MOTION TO CREATE SSA-PH1 REV 08

MOTION: THAT SSA-PH1 REVISION 08 BE
CREATED INCORPORATING THE TECHNICAL
CHANGES TO REVISION 07c LISTED BELOW

LINES AND LINE SEGMENTS

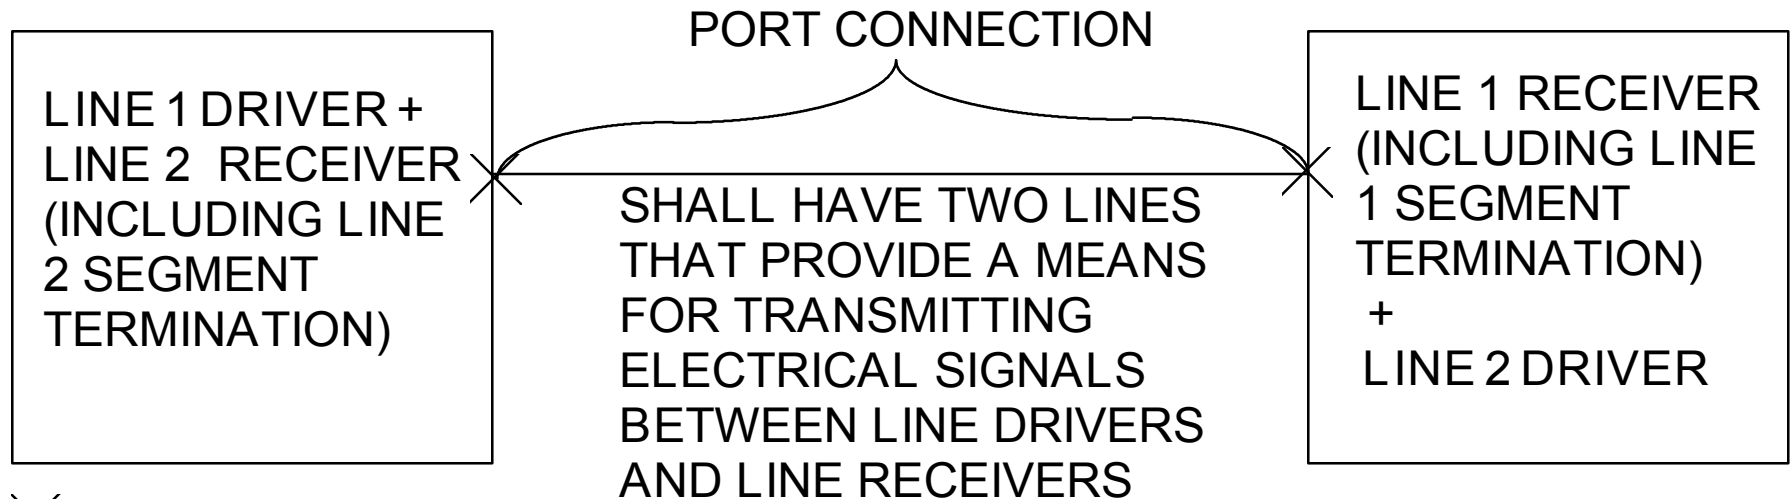
- MOVE CONNECTOR PERFORMANCE REQUIREMENTS TO NORMATIVE ANNEXES
- ADD FIGURES DESCRIBING LINE SEGMENTS, PORT CONNECTIONS, PORT CONNECTION SEGMENTS, PORT CONNECTION COUPLERS, AND COMPLEX PORT CONNECTIONS
- CHANGE LINE SEGMENT TERMINATION REQUIREMENTS TO USE 750 PS RISE TIME INSTEAD OF SLEW RATES
- MOVE EQUALIZER REQUIREMENTS TO CABLE ASSEMBLY SECTION

PORT CONNECTIONS AND PORT CONNECTION SEGMENTS

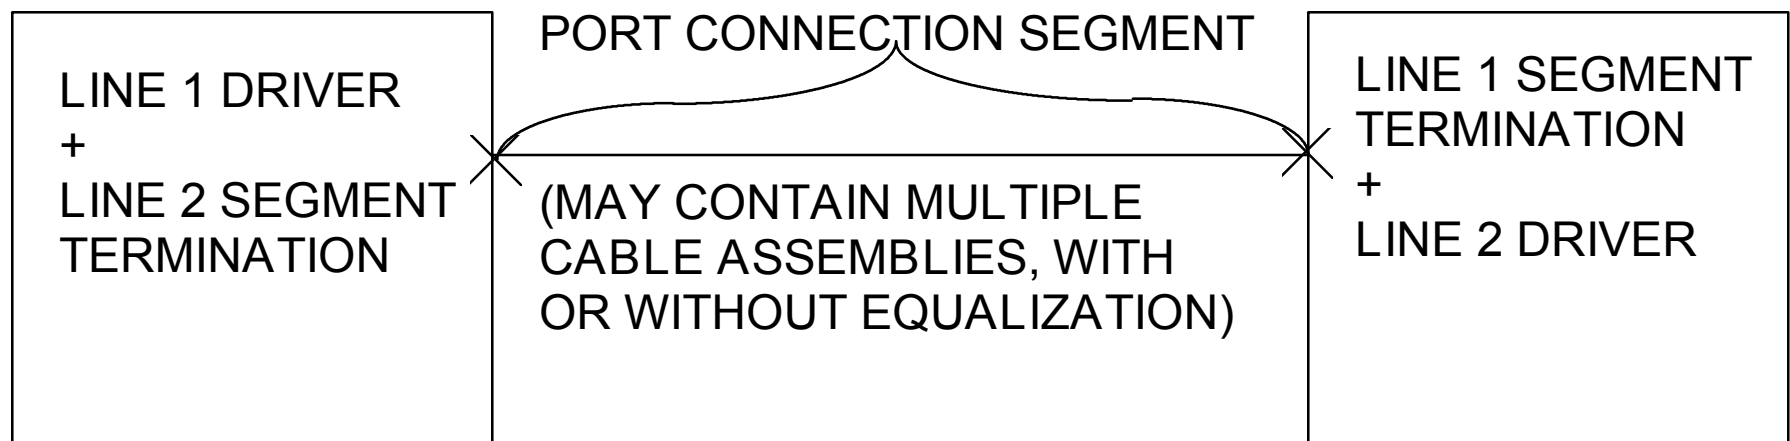
(CONTAINS ONE PORT CONNECTION SEGMENT IF ONLY CABLE ASSEMBLIES, INCLUDING THOSE WITH EQUALIZATION, ARE USED TO IMPLEMENT THE PORT CONNECTION)

COMPLEX PORT CONNECTIONS

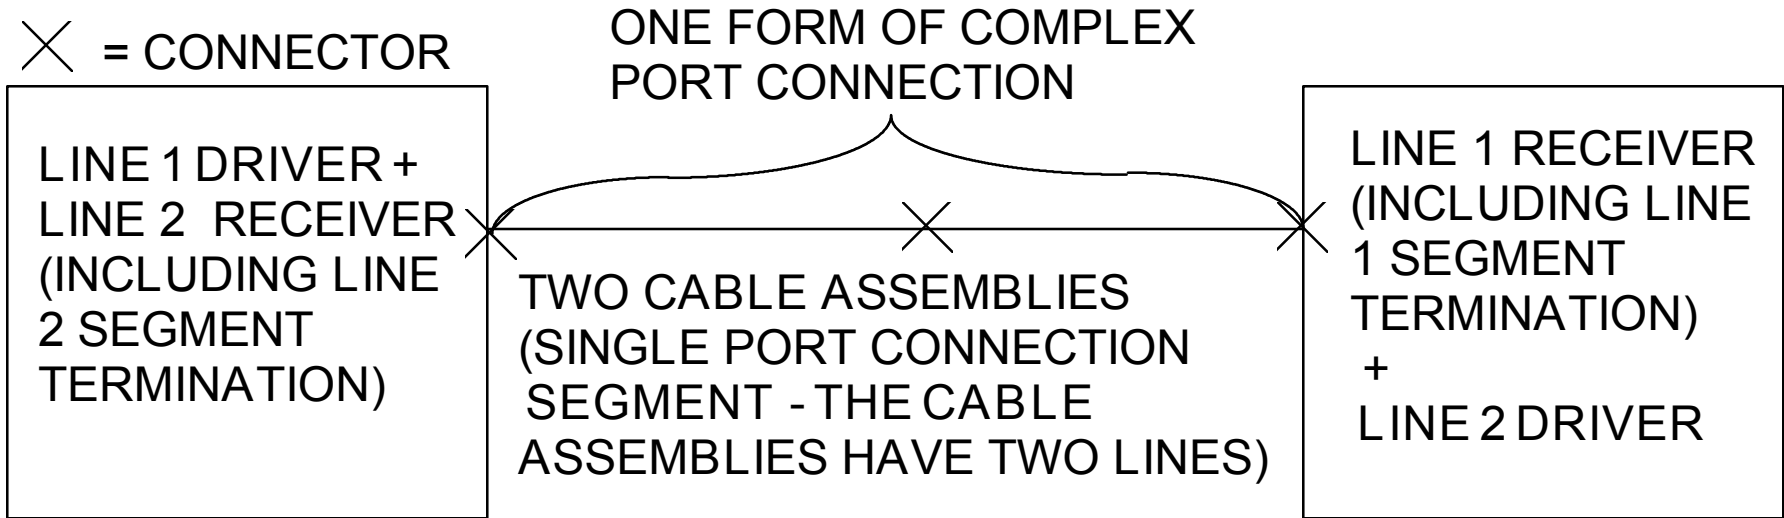
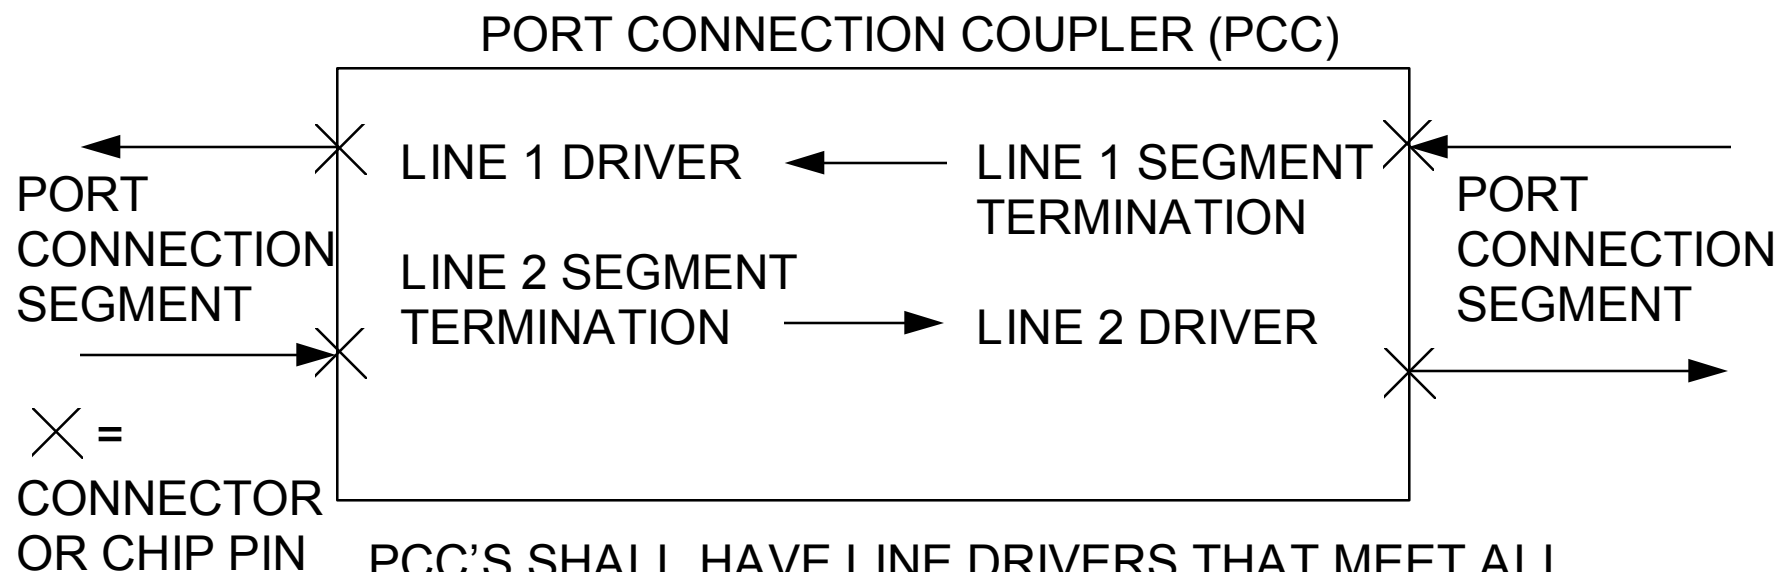
PORT CONNECTIONS IMPLEMENTED WITH SINGLE CABLE ASSEMBLIES USING PASSIVE EQUALIZERS ARE NOT CONSIDERED TO BE COMPLEX PORT CONNECTIONS

COMPLEX PORT CONNECTIONS MAY ALSO BE CREATED BY USING PORT CONNECTION COUPLERS (PCC'S)

PCC'S MAY CONTAIN OPTICAL OR OTHER MEANS FOR TRANSMITTING SIGNALS WITHIN THE PCC BETWEEN THE SEGMENT TERMINATION SIDE AND THE LINE DRIVER SIDE

PCC'S SHALL HAVE LINE DRIVERS THAT MEET ALL PERFORMANCE REQUIREMENTS FOR SSA PORT LINE DRIVERS WITH ANY COMPLIANT SSA LINE RECEIVER SIGNALS AT THE LINE SEGMENT TERMINATION SIDE

PCC-LIKE ELEMENTS WITHIN A COMPLEX PORT CONNECTION MAY NOT BE INTERCHANGEABLE AND PORT CONNECTION SEGMENT LENGTHS MAY NEED TO BE REDUCED UNLESS THE REQUIREMENTS OF PCC'S AS DEFINED ARE MET -- ONLY THE REQUIREMENTS AT THE PORT CONNECTORS APPLY FOR COMPLEX PORT CONNECTIONS THAT DO NOT REQUIRE INTERCHANGEABILITY FOR PCC-LIKE ELEMENTS OR LONG PORT CONNECTION SEGMENTS
